Forest River, Inc.

11V-010
(8 Pages)

RE: Attached 573 recall on R-Pod trailers for 571.108 non-compliance.

R-POD

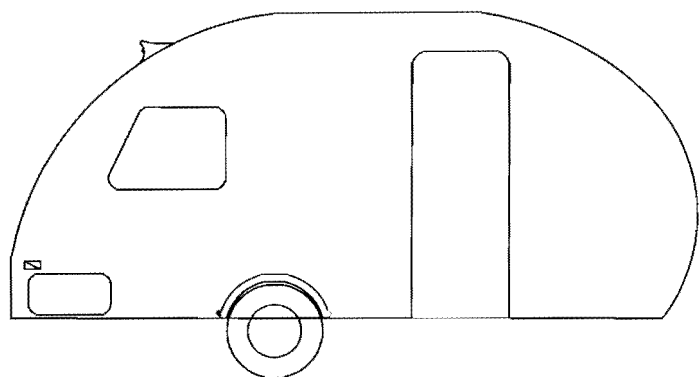
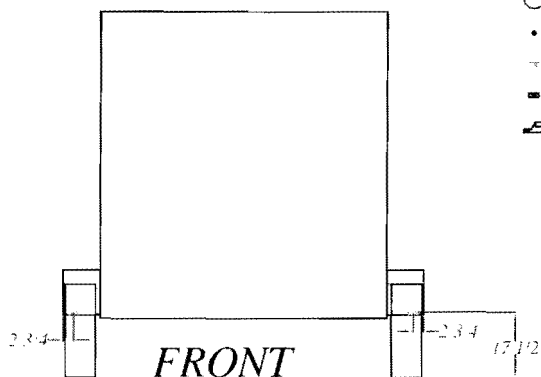
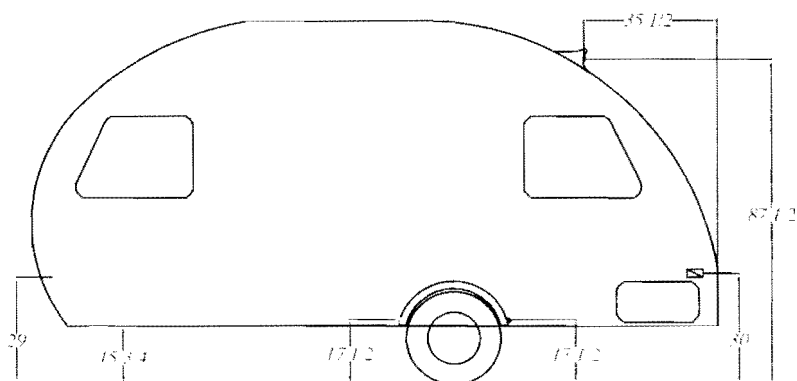
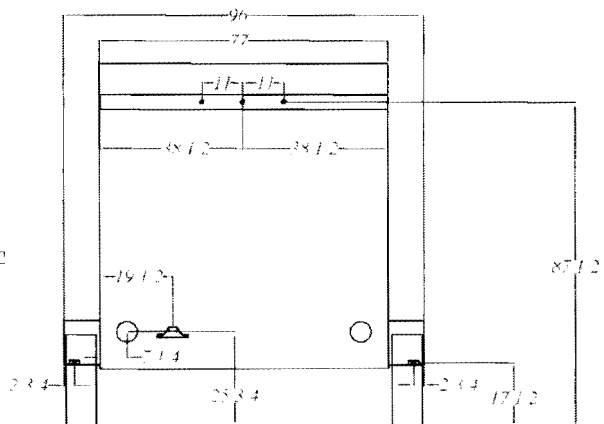
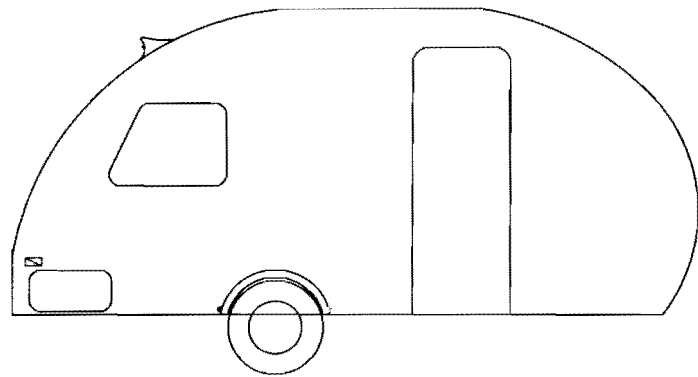
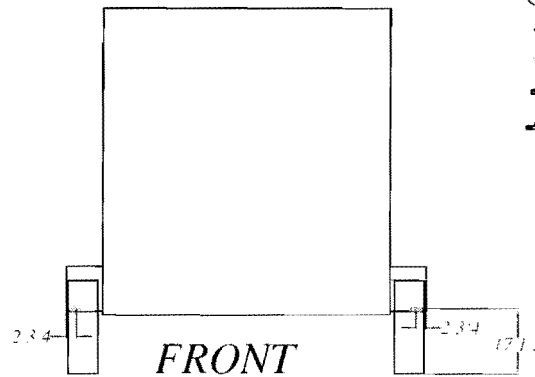
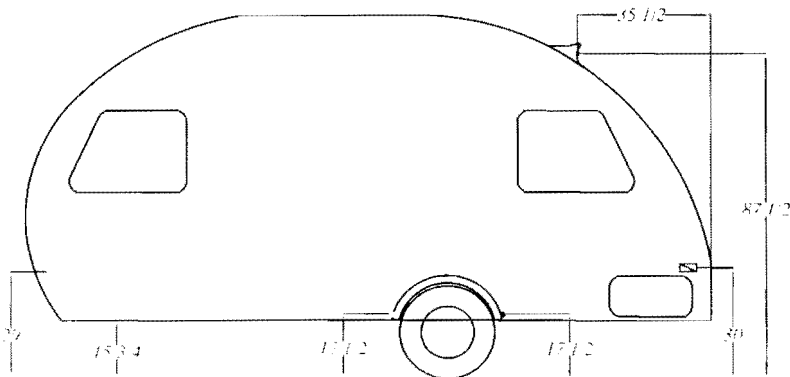
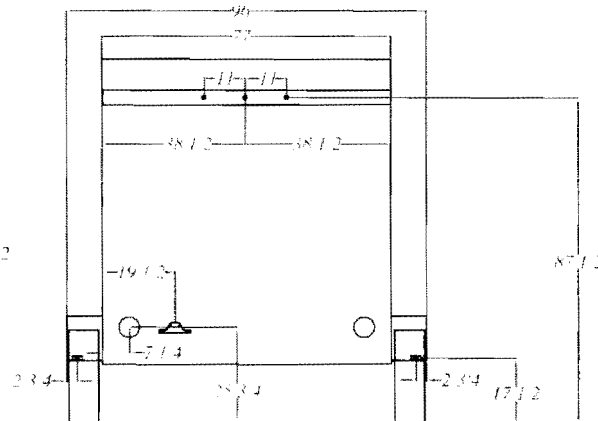
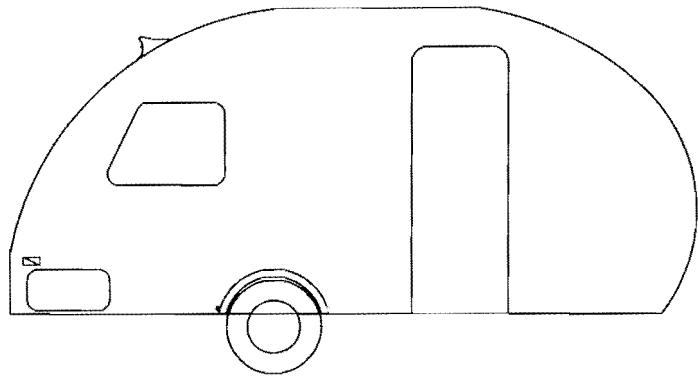
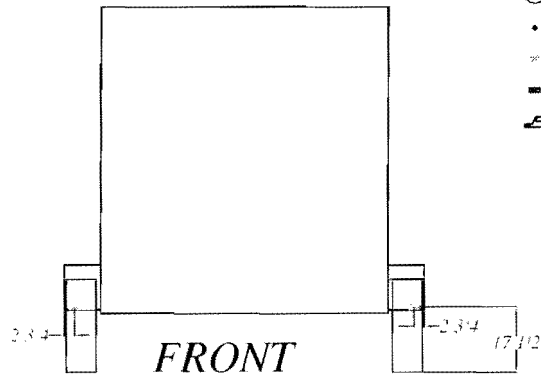
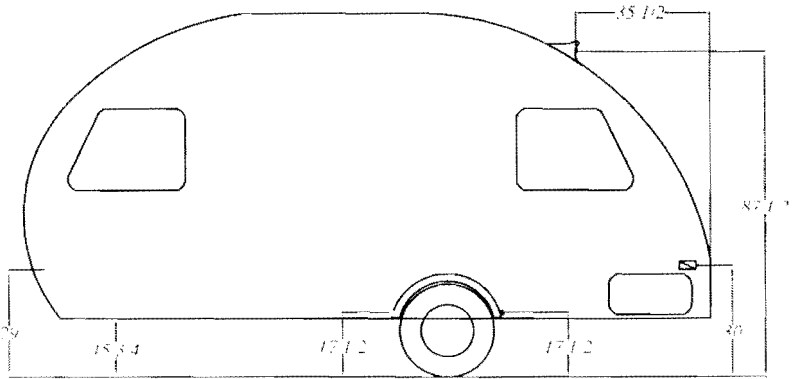
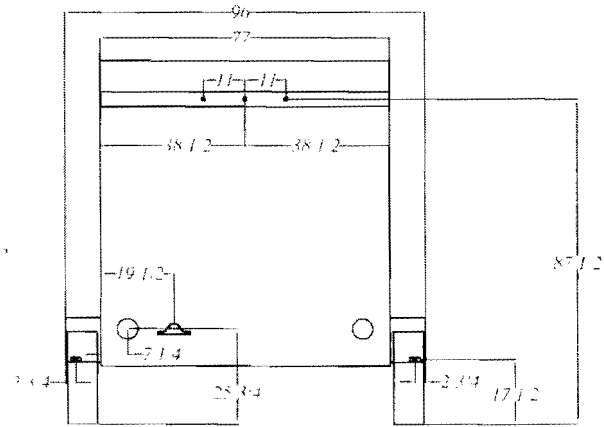
Forest River recognizes the error of the interpretation of the standard and has rectified all R-Pods built as of December of 2010 by adding the clearance lights to the fenders, amber in front and red on the rear along with a red reflector on the rear of each fender. We have also added a spoiler to the rear of the unit to house the 3 red rear marker lights indicating the height.

Enclosed is a drawing indicating the corrections that have been made to the product to meet the requirements of 571.108.

The remedy for the affected travel trailers would involve placing the DOT approved clearance lights on the fender of the trailer indicating the over all design width and a spoiler on the rear as high as applicable to house the marker lights.
